GREAT LAKES INDIAN FISH & WILDLIFE COMMISSION

April 30, 2013

Potential impacts to wetlands due to groundwater drawdown at the NorthMet mine site

Figure 1: Analog Drawdown Contours in Relation to Proposed NorthMet Pits

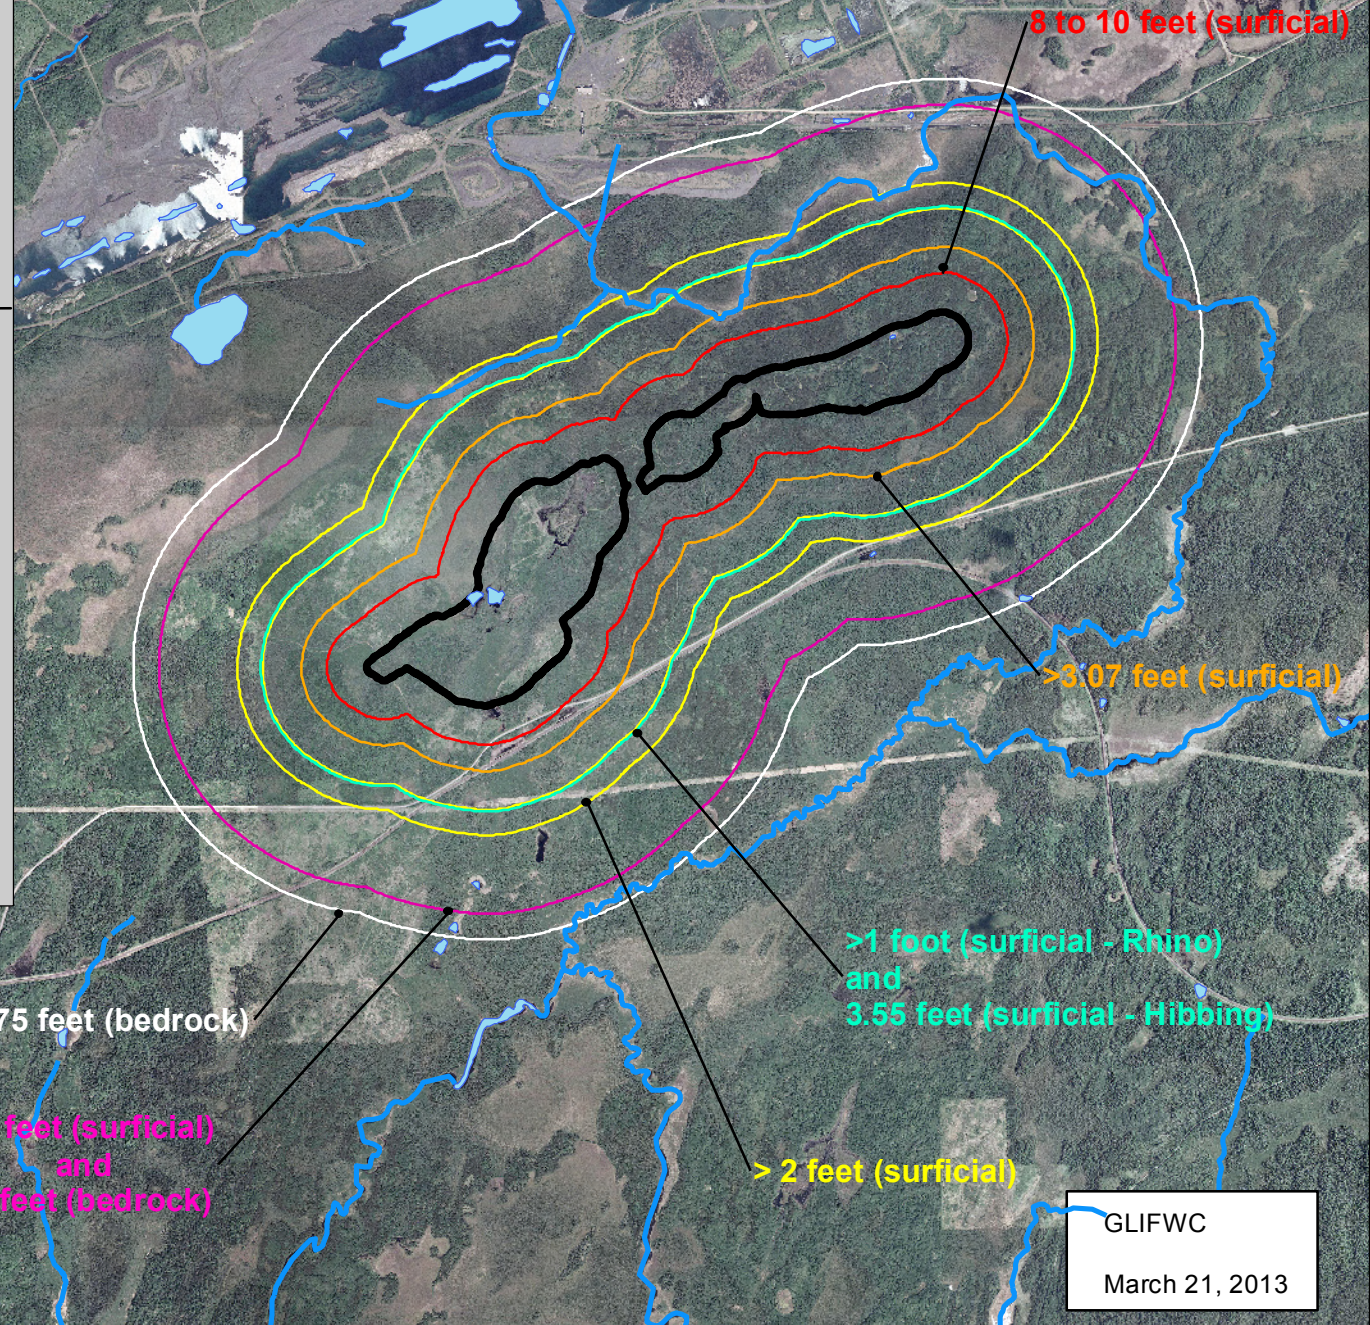
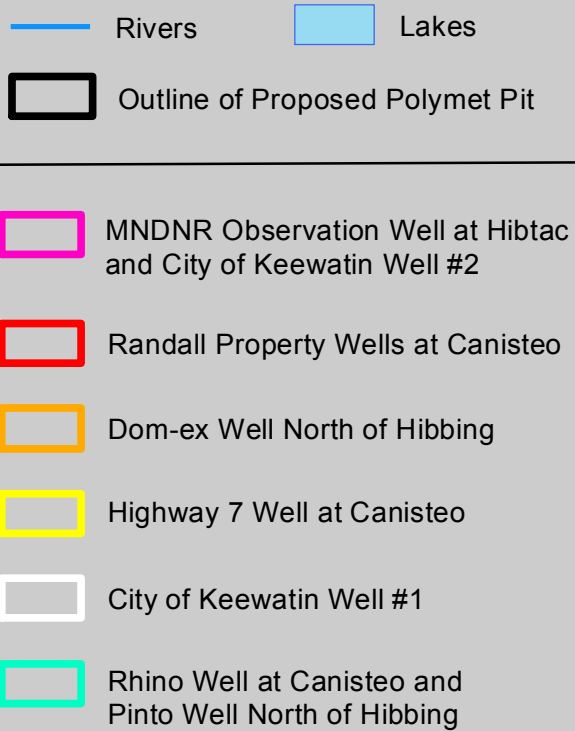
Contour lines showing the analog well information in relation to the proposed NorthMet mine site are provided in Figure 1.

Wetlands within Zone 1 are depicted in Figure 3. Information provided by MNDNR Mining Hydrologist Michael Crotteau indicates that 2 wells at the Randall property (Wells T3 and T4) were artesian before a drain tile was installed to reduce groundwater levels in the area. This indicates a strong hydrologic connection between these wells and the Canisteo pit approximately 700 feet from the edge of the pit (Figure 4). The basement of the Randall residence was built when the Canisteo pit was dewatered is at an elevation of 1300 feet above sea level. The surface elevation at the site is 1310.73 feet above sea level. This indicates at least an 8 to 10 foot increase in the elevation of the water table 792 feet away from a reflooded Canisteo pit.

Based on these analog wells, a drawdown of up to 10 feet could affect wetlands in zone 1. We believe it is reasonable to assume that 5 to 10 feet of drawdown would occur throughout zone 1. In addition, these wetlands are often remnants of wetlands directly impacted by the pits and stockpiles, are surrounded by roads and ditches, and directly border the pits. Therefore, all wetlands in zone 1 are assessed as severely impacted (Table 1).

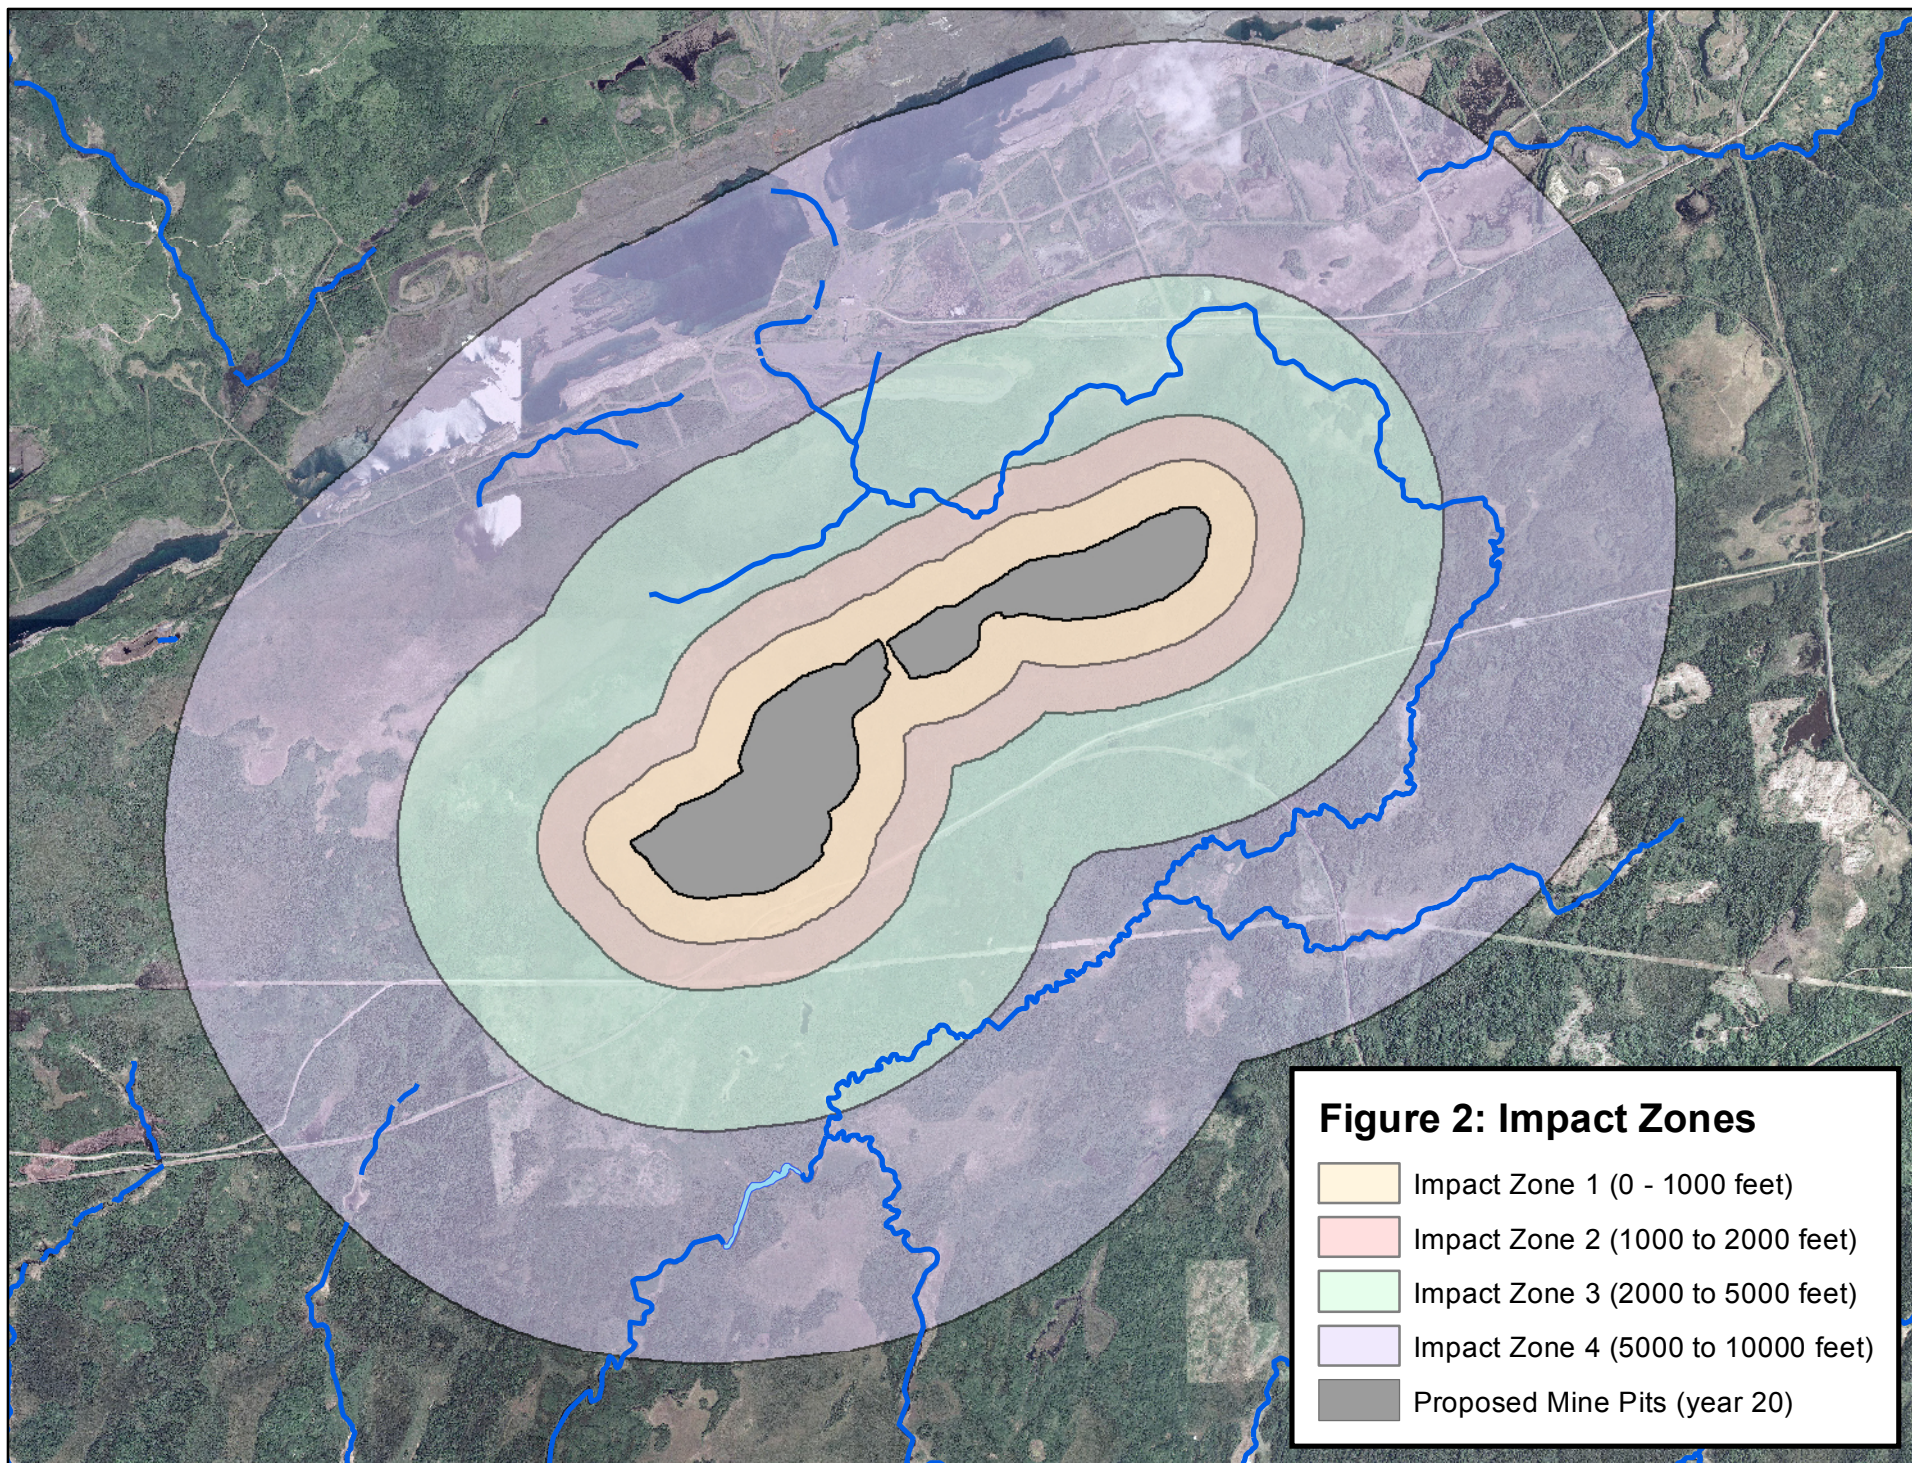
GLIFWC impact zones (Figure 2) are:

- Zone 1 – 0 to 1000 feet from the mine pit edge.
- Zone 2 – 1000 to 2000 feet from the mine pit edge.
- Zone 3 – 2000 to 5000 feet from the mine pit edge.
- Zone 4 – 5000 to 10000 feet from the mine pit edge.

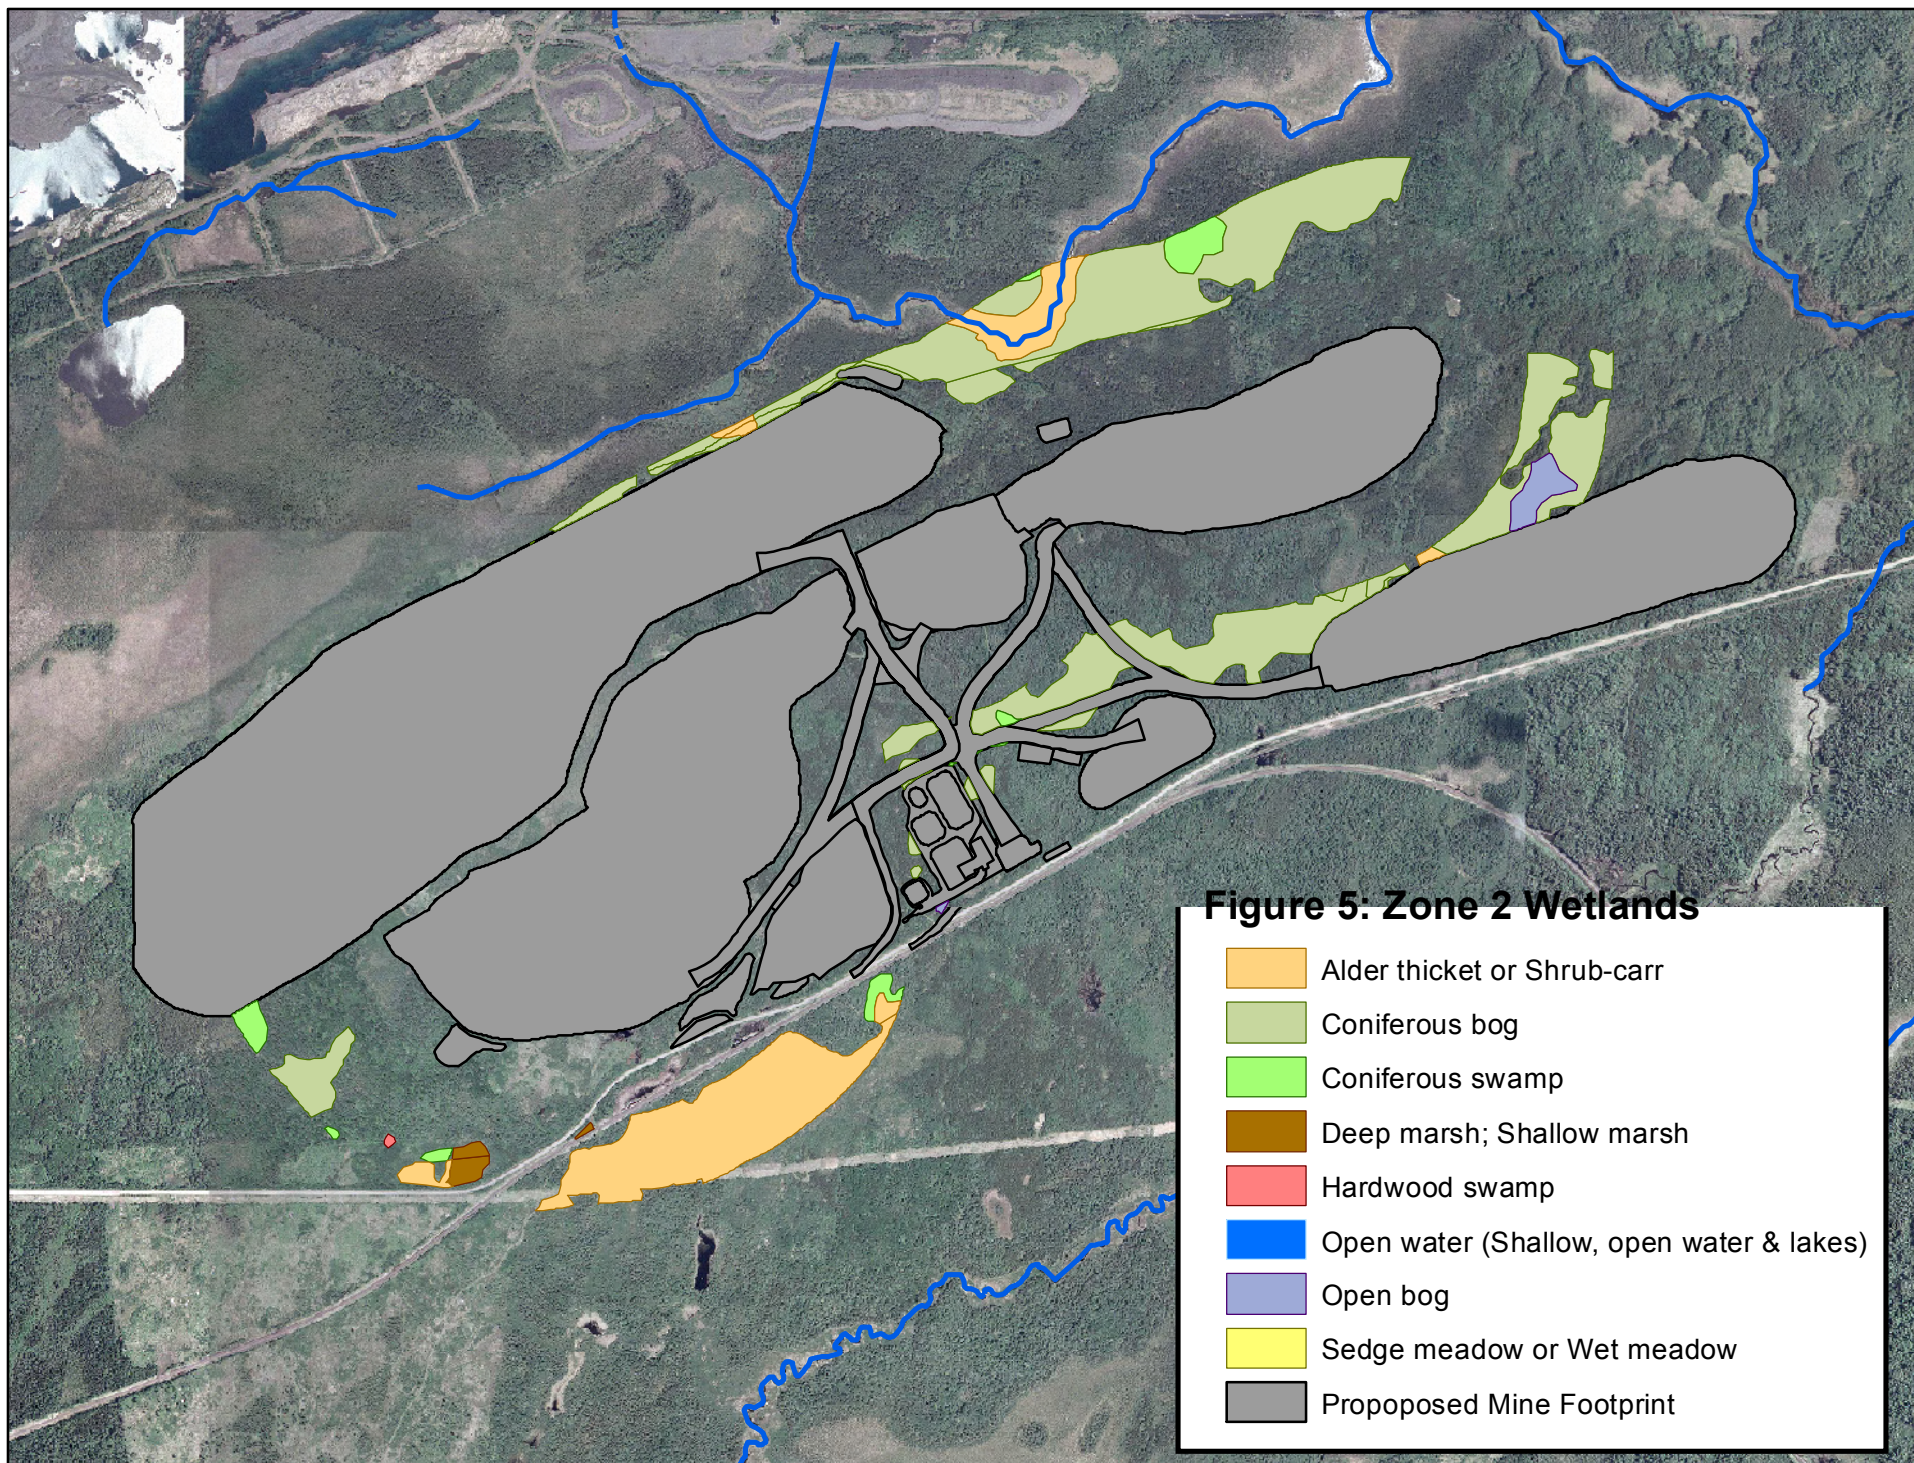
Wetlands within zone 2 are depicted in Figure 5. The Dom-ex well is located on the north side of the city of Hibbing is 1320 feet from the nearest dewatered pit at Hibtac. According to Mr. Crotteau this well experienced a drop of 3.07 feet in response to pit dewatering. Because wells in zone 3 (discussed below) indicate drawdown values ranging between 1 and 3 feet, and wells in zone 1 indicate dewatering of up to 10 feet, this analysis assumes that drawdowns in zone 2 are on the order of 3 to 5 feet. In addition to drawdown, wetlands in zone 2 are remnants of wetlands directly impacted by the project, are surrounded by roads, ditches and other mine features, or have sections in zone 1. These wetlands can also be impacted by aerial deposition of mine related contaminants. The impact assessment for wetlands in zone 2 are outlined in Table 2.

It is important to note that a section of the upper Partridge River is located within Zone 2. Drawdowns of 3 to 5 feet under a river could severely reduce baseflow leading to reductions in flow in the river channel. Reductions in flow could indirectly impact riparian wetlands downstream.
